ADDENDUM NO. :	Two (2)
BID DUE TIME AND DATE:	2:00 p.m.DST, Thursday April 9, 2020 (CHANGED)
SUBSTITUTION REQUEST: (in accordance with 00 21 13, 01 25 13, and 01 60 00)	Noon, Thursday April 2, 2020
BIDDER LAST QUESTIONS BY:	2:00 p.m., Friday April 3, 2020
LAST ADDENDUM ISSUED:	10:00 a.m., Monday April 6, 2020

- **NOTICE: BID DATE AND PROCEDURE CHANGE;**
 - **To provide a response to questions raised by Plan Holders; and,**
 - **To modify/clarify specifications & drwgs as a result of items above and identified by A/E Team.**
- Addendum 3 is scheduled to be released by 2pm Tuesday, 03/31/20 or earlier*; generally it addresses:
- Product Submittal clarification;
 - Signage clarification;
 - Door Schedule and Hardware Sets, Summary of Work, Alternates, update per this Addendum 02;
 - As well as address various Bidder questions.

RENOVATION WITH ADDITION TO BUILDING V ST. AUGUSTINE CAMPUS

ST. JOHNS RIVER STATE COLLEGE

A501

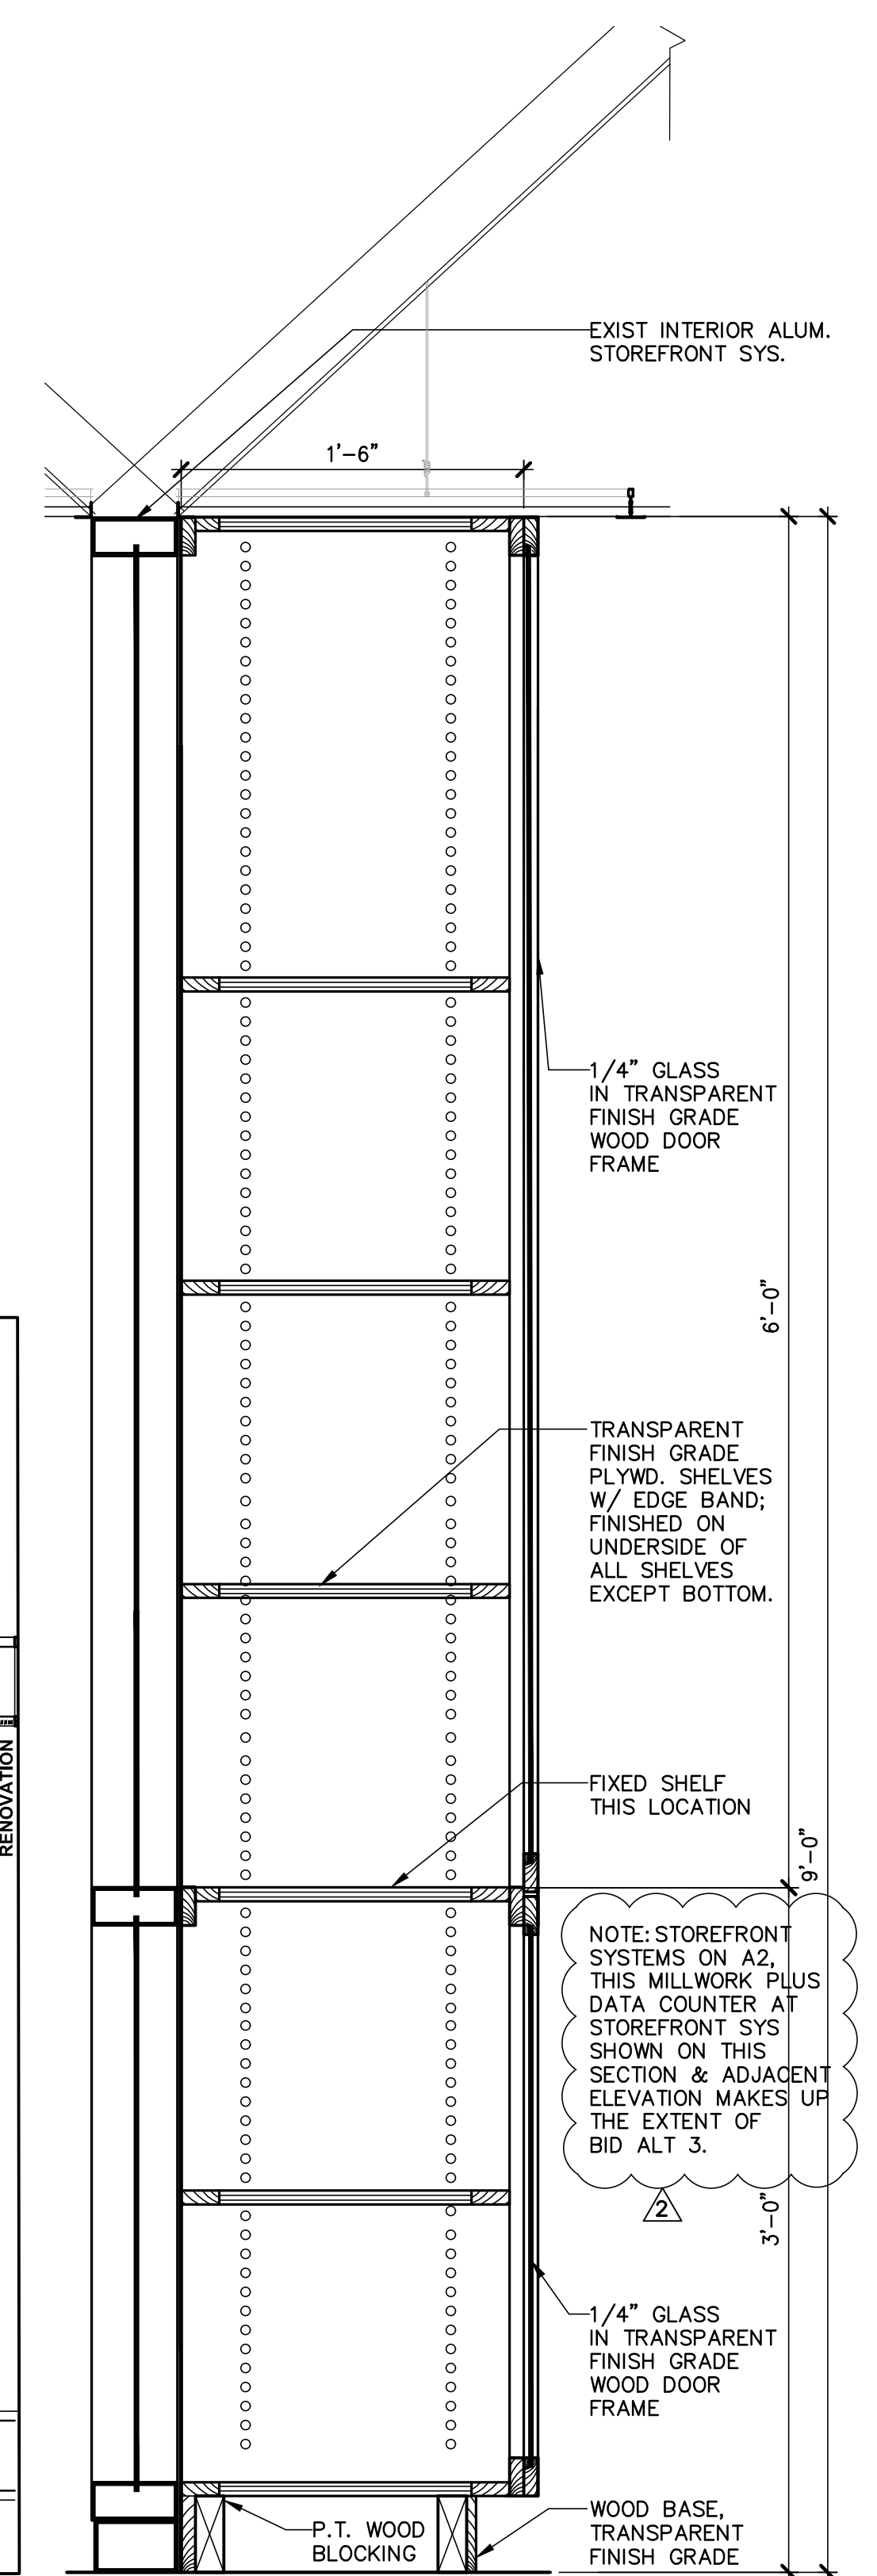
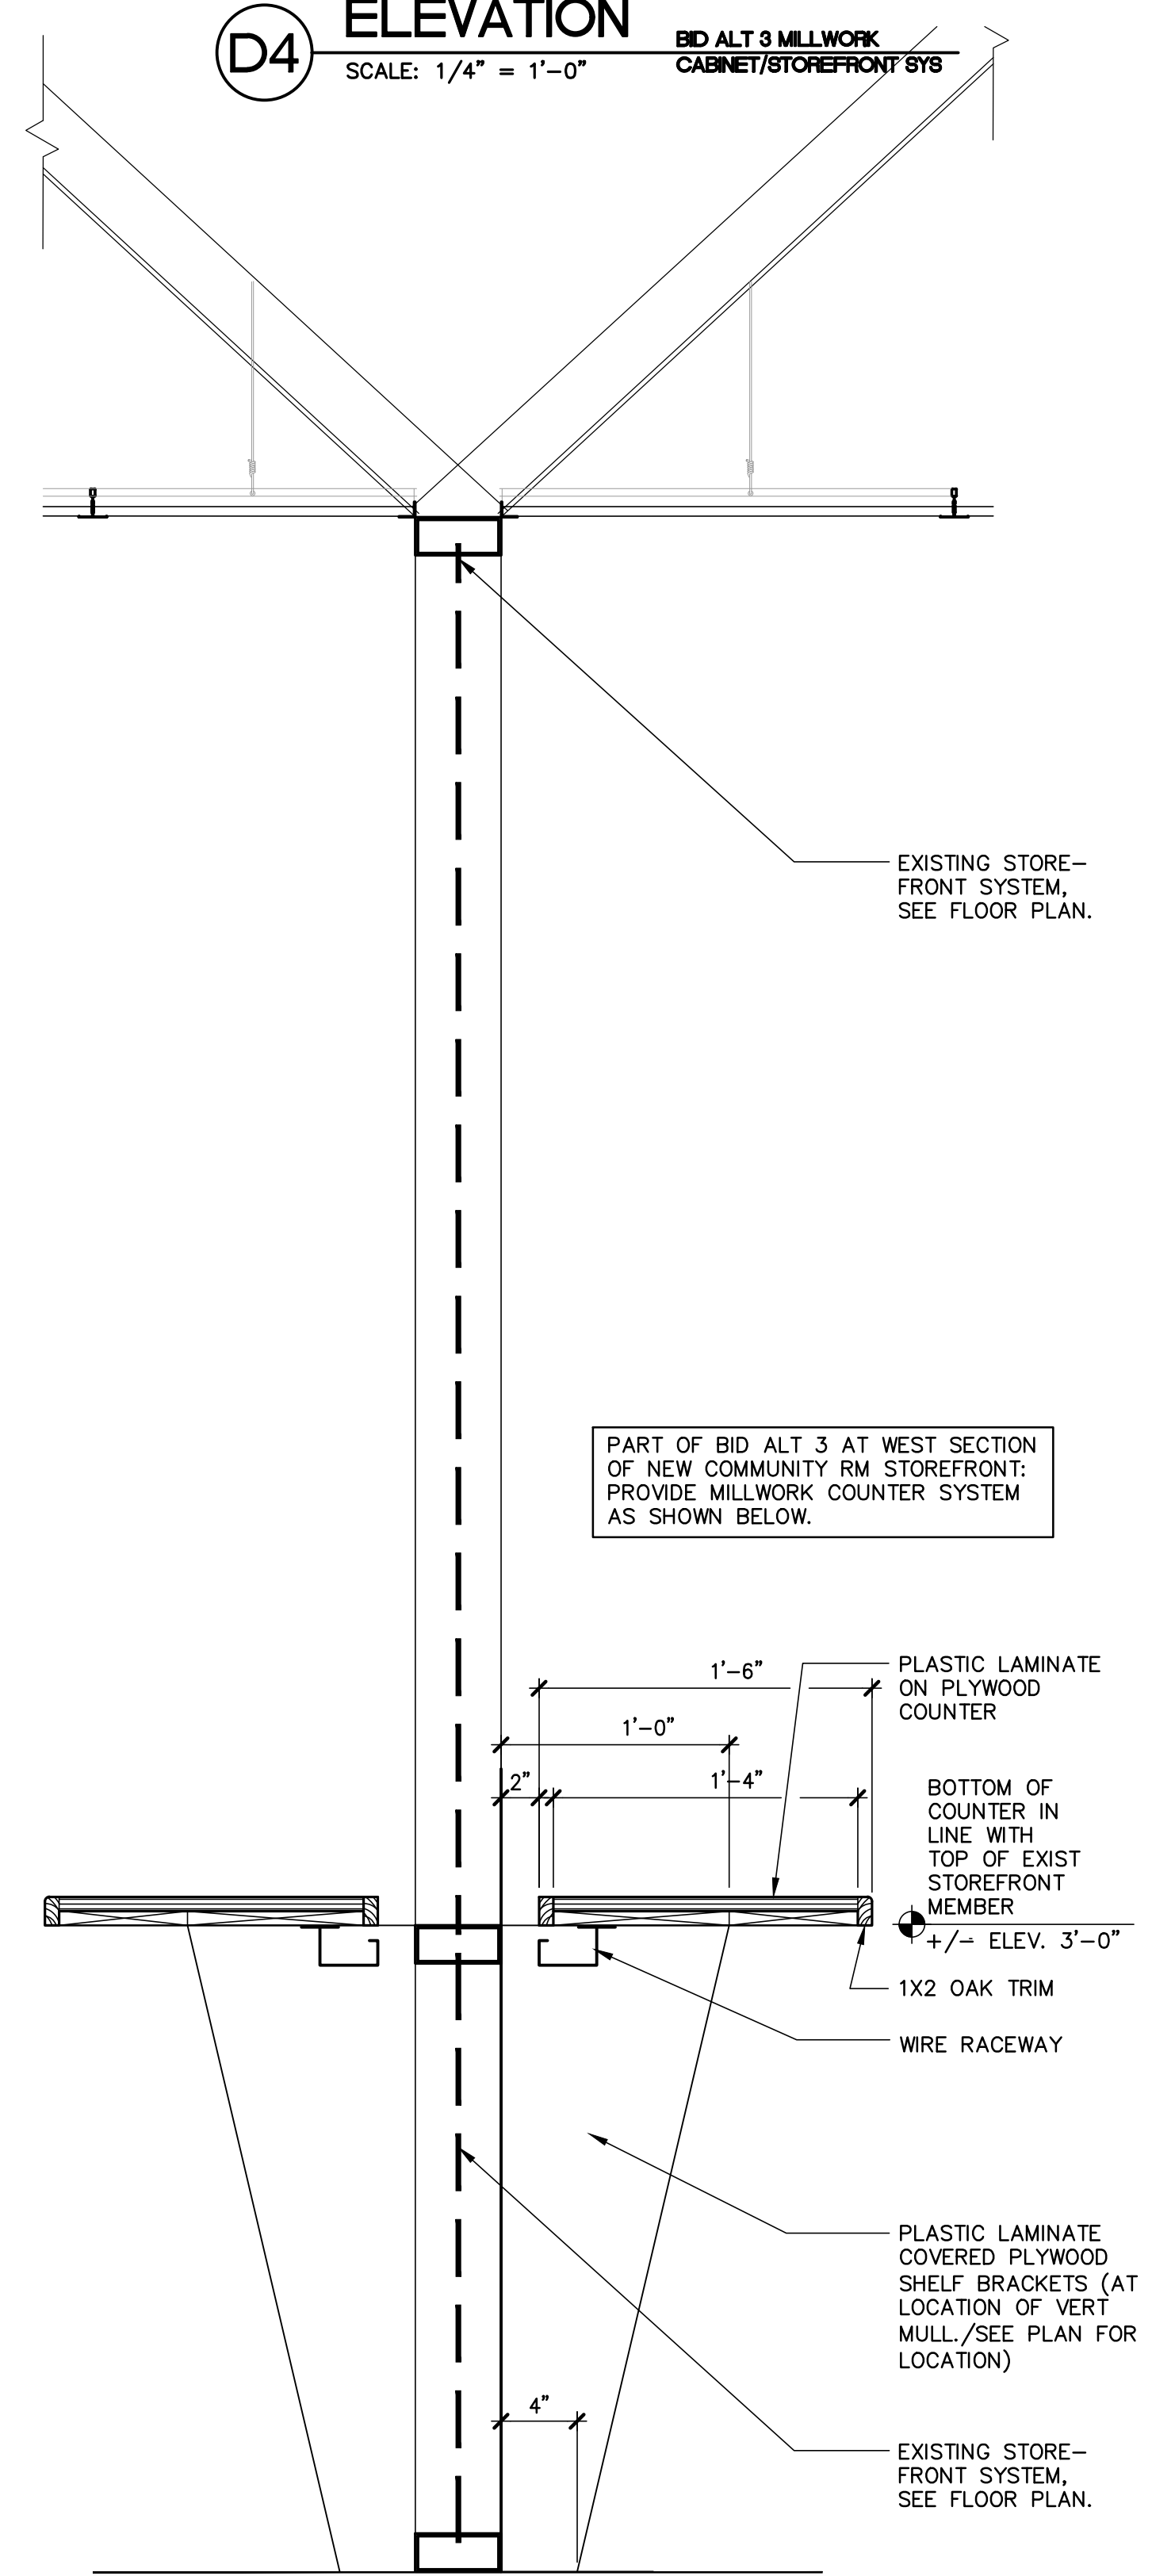
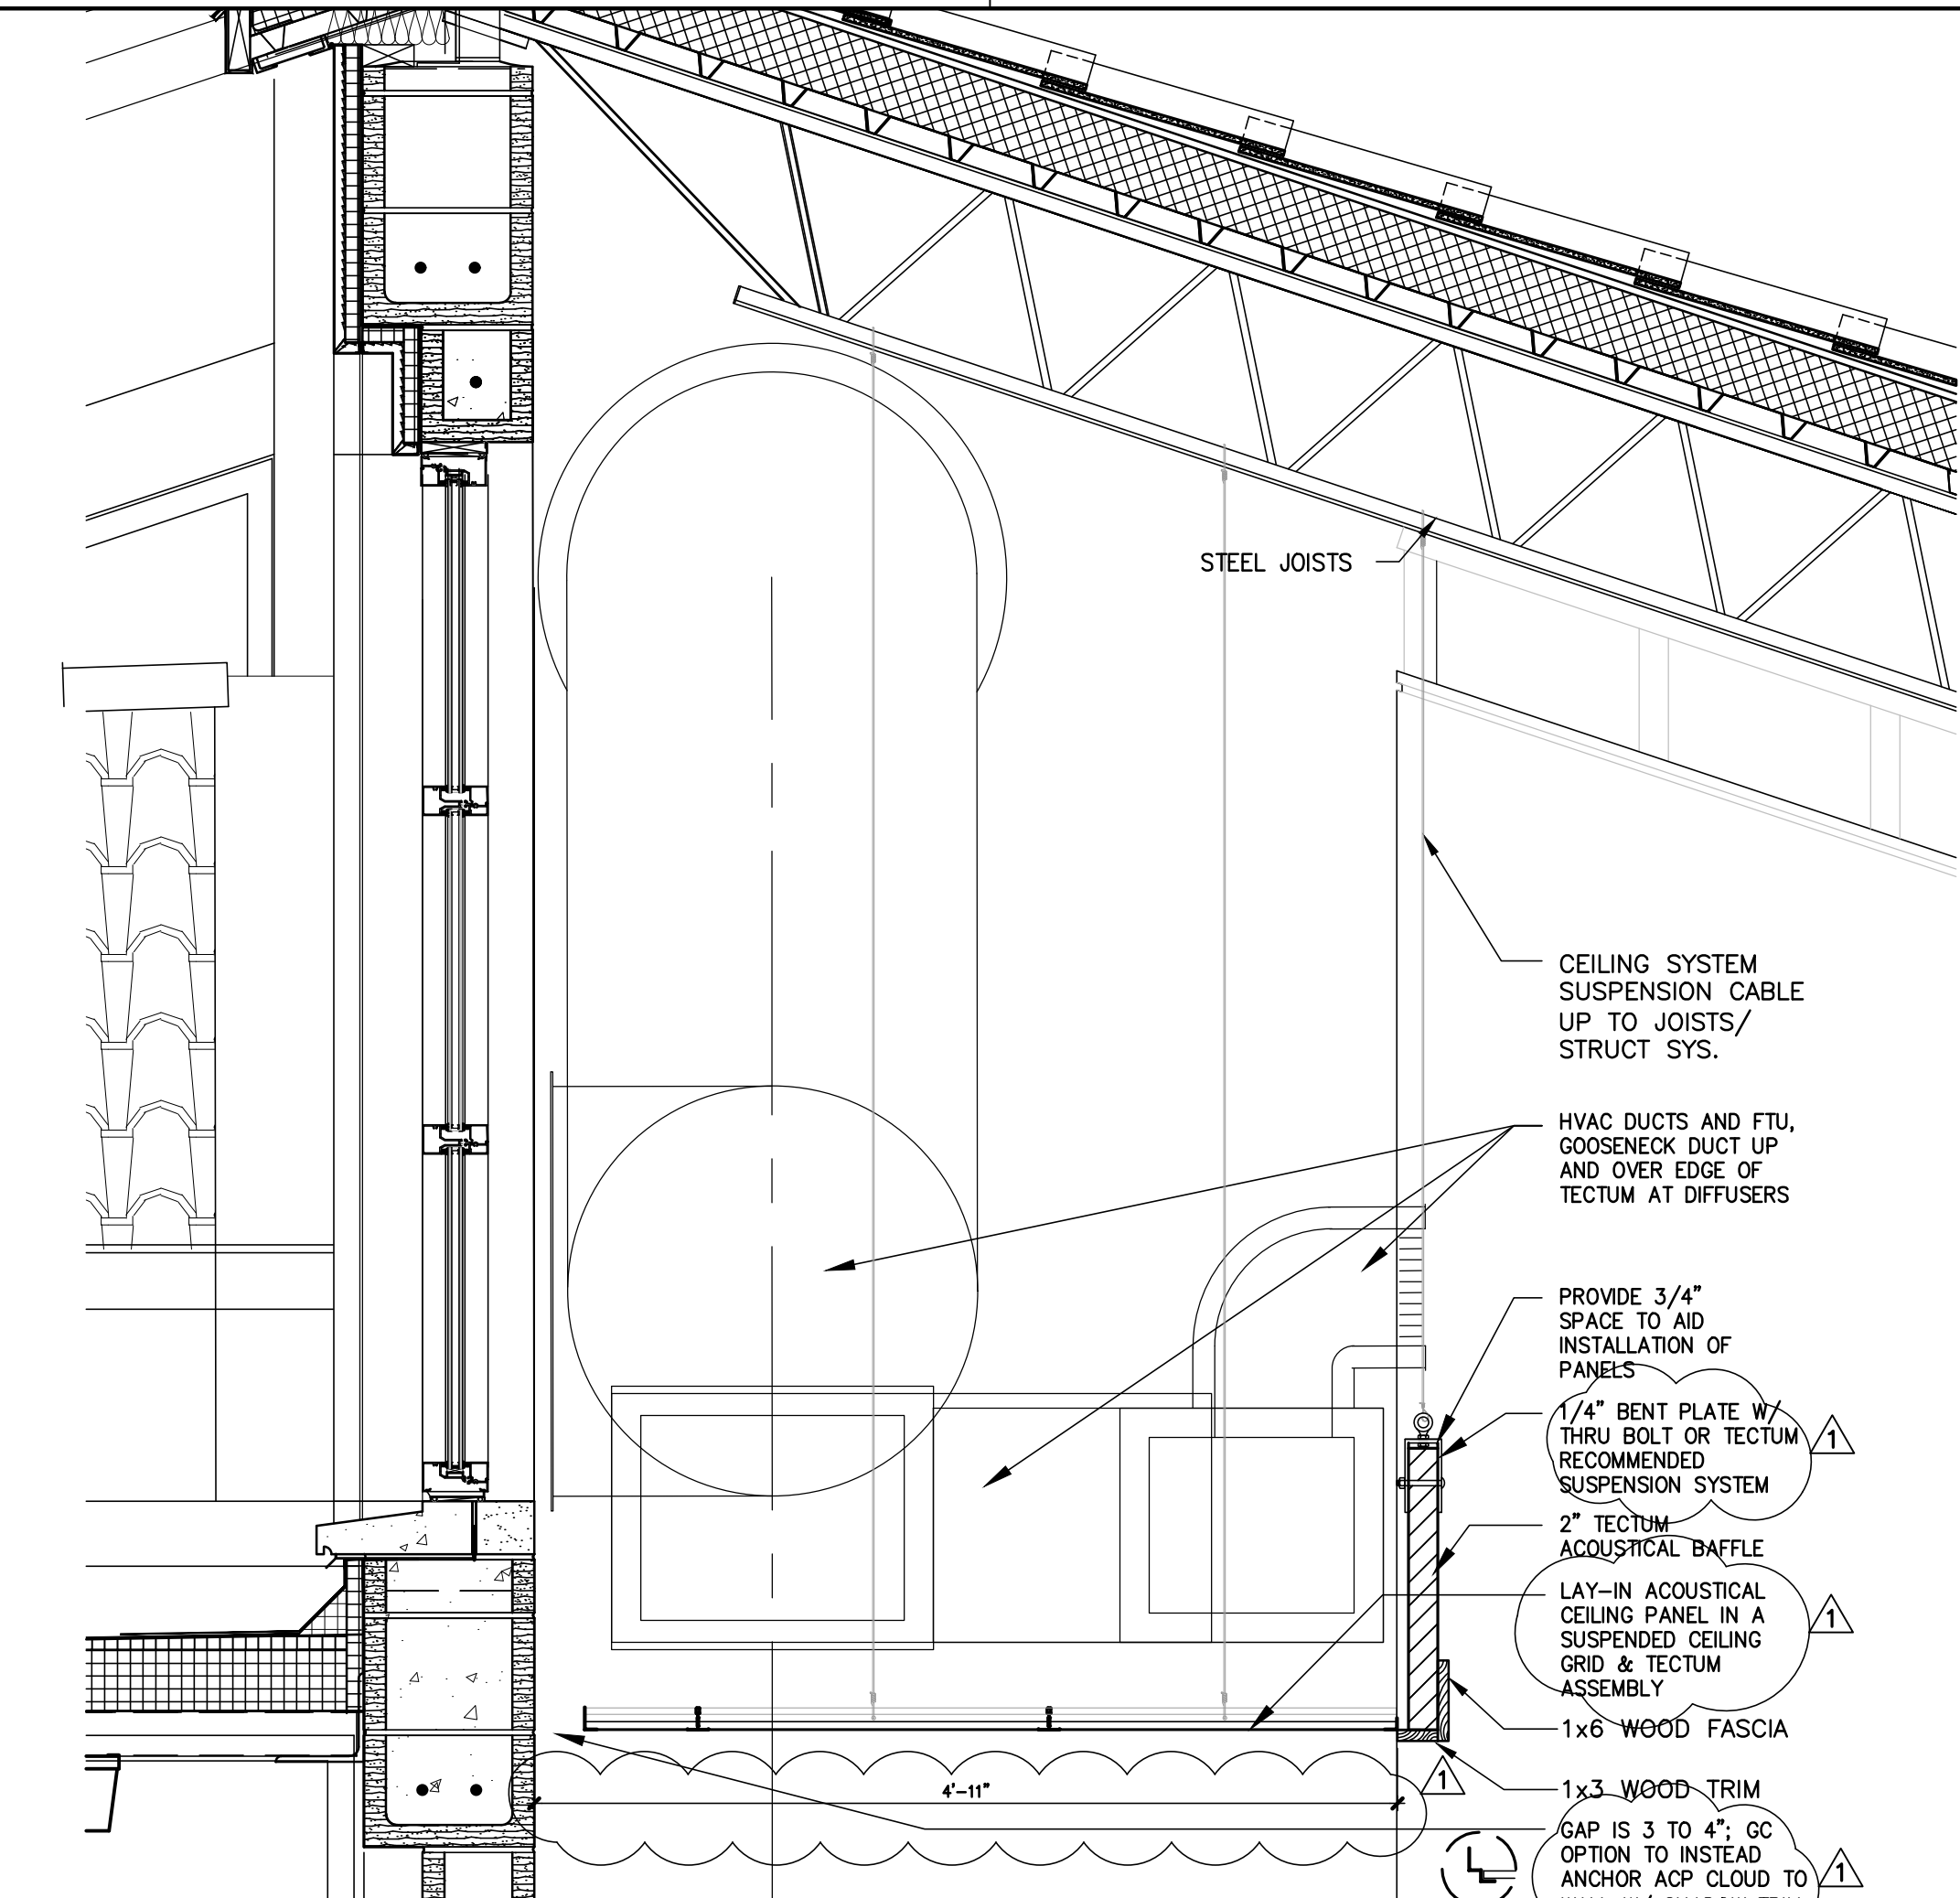
Additionally regarding Storefront: to move non-essential Work within Existing Building V to Bid Alternate 3, see attached revised A101 and A501 where storefront pairs of doors work shifts from Base Bid to Bid Alternate 3:

- PART OF BID ALTERNATE 3: REPLACE EXIST SINGLE PAIR OF STOREFRONT DOORS AND ADJACENT SIDELITES WITH TWO (2) NEW PAIR & ASSOCIATED TRANSOM LITE ABOVE. PROVIDE FLOOR LVT TRANS. CONTRACTOR OPTION TO DEMO/SALVAGE EXIST STOREFRONT PAIR OF DOORS FOR USE IN ADDITION NEW BOOKSTORE LOCATION, INCL. HARDWARE.
- PART OF BID ALTERNATE 3: IN EXIST CASED OPENING PROVIDE SINGLE PAIR OF STOREFRONT DOORS AND ADJACENT SIDELITE. CONTRACTOR OPTION TO USE ABOVE REFERENCED SALVAGED EXIST PAIR OF DOORS FOR USE IN THIS LOCATION (NOT BOOKSTORE), INCL. HARDWARE.

- A101, A102 – Table notations (Q1/A1), as well indication of BASE BID at Existing Bldg V.
- A101, A102, A501 – Storefront changes (Q3/A3).
